MODIFICATION

ENGINE OIL FILLER CAP WASHER.

BENTLEY MARI

MODEL BENTLEY MARK VI

FOR INFORMATION:CORE PLUGS.

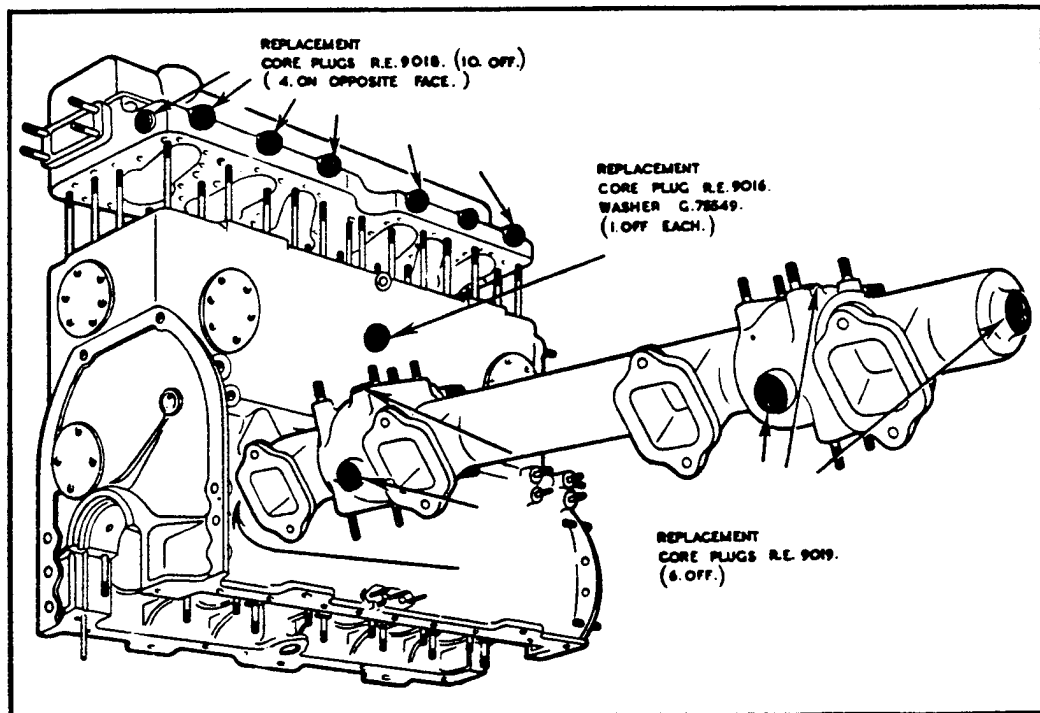
The following illustration gives fuller details of the location of the core plugs to be replaced, together with replacement part numbers.

It should also be noted that if a coolant leak develops from any of the core plugs when the engine is fitted with the pre-modified type, this may indicate that a state of corrosion exists in other core plugs caused initially by the engine remaining drained of coolant for lengthy periods of storage or shipment. If a leak is apparent therefore, the instructions given in Bulletin BB-19, limiting this modification to overhaul cases only, must be disregarded, and all core plugs replaced with the modified type.
